SUBJECT: Results of Planning & Zoning Commission Meeting of October 5, 2020

ZONING CASE 2020-010

Subject: **Zoning Case #ZC2020-010**

Public Hearing: Zoning Case 2020-010

UPDATED CONCEPT PLAN - OCTOBER 5, 2020

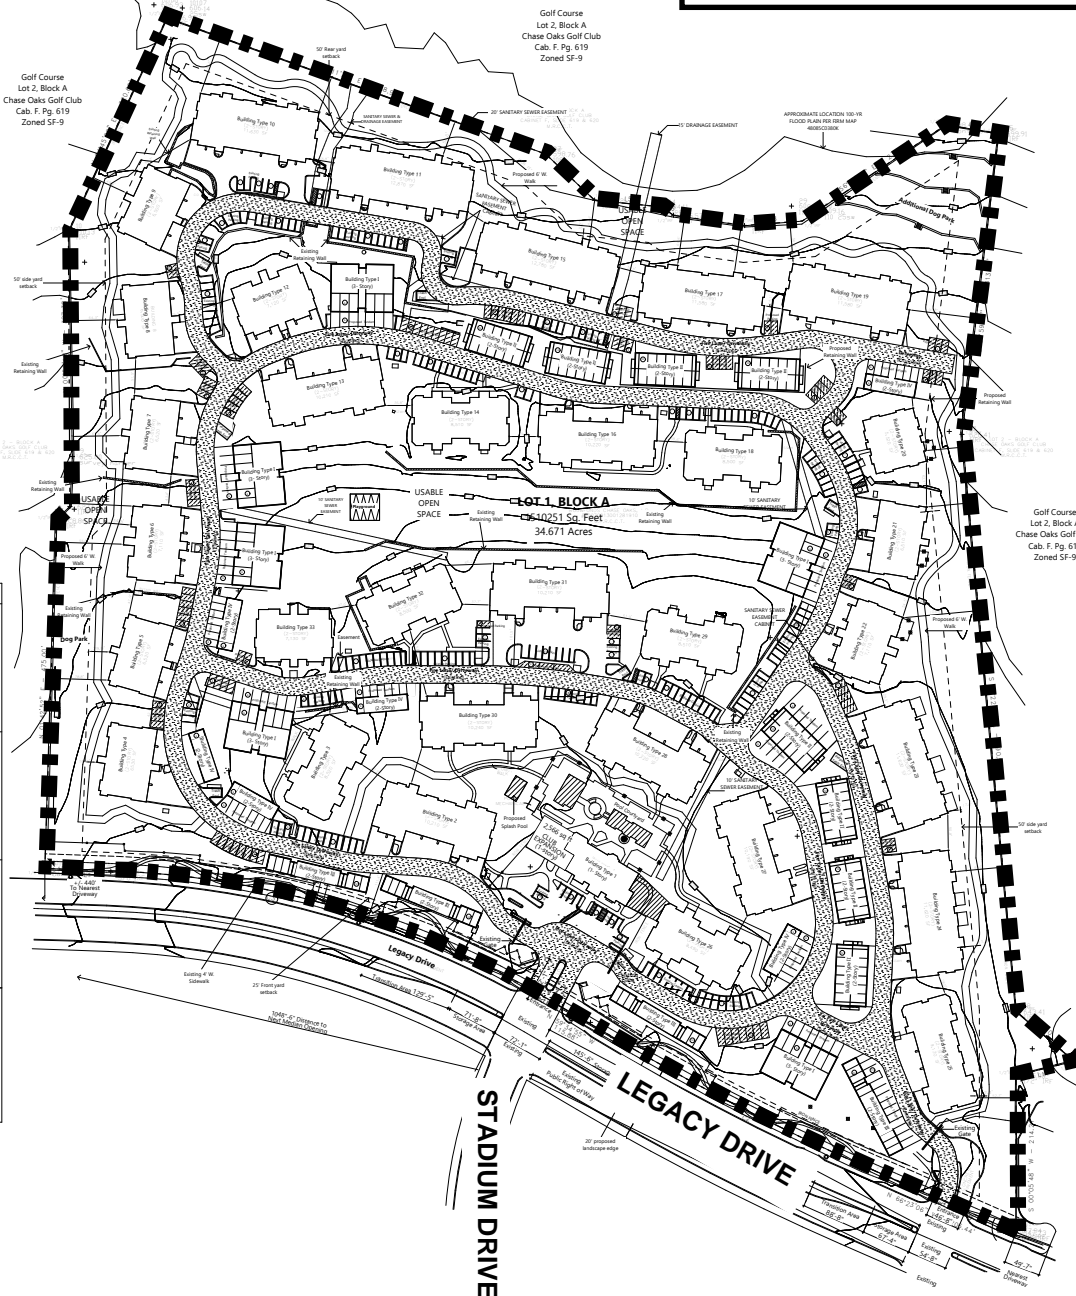
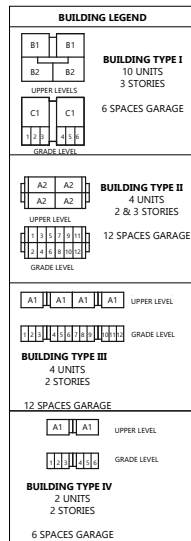
- Additional density, especially along Legacy Drive;
- Removal of the trees along Legacy Drive;
- The existing setback along Legacy Drive should be preserved;
- Buildings should be removed from Legacy Drive frontage to leave green space;
- Placing buildings close to Legacy Drive takes away the visual impact;
- The request is not respectful of setbacks; and
- The applicant should revise the request and consider isolating their new development to the interior, removing units from Legacy.

1. Change reduction in landscape edge along Legacy Drive by five feet. The existing landscape edge is 50 feet. The applicant originally proposed a 30-foot reduction, resulting in a 20-foot landscape edge. Based on P&Z's feedback, the applicant has modified their request to include a 25-foot landscape edge. Staff does not find this change consistent with the direction from P&Z at the September 8, 2020, meeting, as noted earlier in this report.
2. Enhance landscaping requirements along Legacy Drive. Staff visited the site and took a brief survey of the trees along Legacy Drive. The existing conditions are noted below.

Staff placed an overlay of the concept plan on an aerial to review the impacts to existing trees. After reviewing this plan, staff estimates the loss of approximately 30 trees, which

equates to 70 percent of the trees behind the existing fence to accommodate the new development and associated parking. An example of this overlay is below:

Additionally, the applicant is proposing ordinance language, “all reasonable effort,” which will be difficult to enforce and is unclear as to the standard of care, as noted below:

To create a clear and enforceable standard, if the P&Z supports this addition, staff recommends utilizing established tree preservation language that corresponds with the Zoning Ordinance. The following language is recommended, with two options depending on the priorities of the Commission. One option maximizes tree health and spacing as a priority. Alternatively, if screening of the buildings is the priority, the number of trees should be limited to the landscape edge along Legacy Drive:

- For tree health: All trees removed from the Legacy Drive frontage will be mitigated. Trees which are removed must be replaced with the same number of caliper inches removed. A variety of tree sizes and types may be used. Replacement trees must be located within 200 feet of the front property line.
- For screening: All trees removed from the Legacy Drive frontage will be mitigated. Trees which are removed must be replaced with the same number of caliper inches removed. A variety of tree sizes and types may be used. Replacement trees must be located within the landscaped edge along Legacy Drive.

1. Maximum number of Units: 460
2. Minimum Front Yard Setback: 50 feet
3. Minimum Landscape Edge along Legacy Dr.: 50 feet. A 6-foot tall combined masonry wall and decorative metal fence may be along or within the landscaped edge.
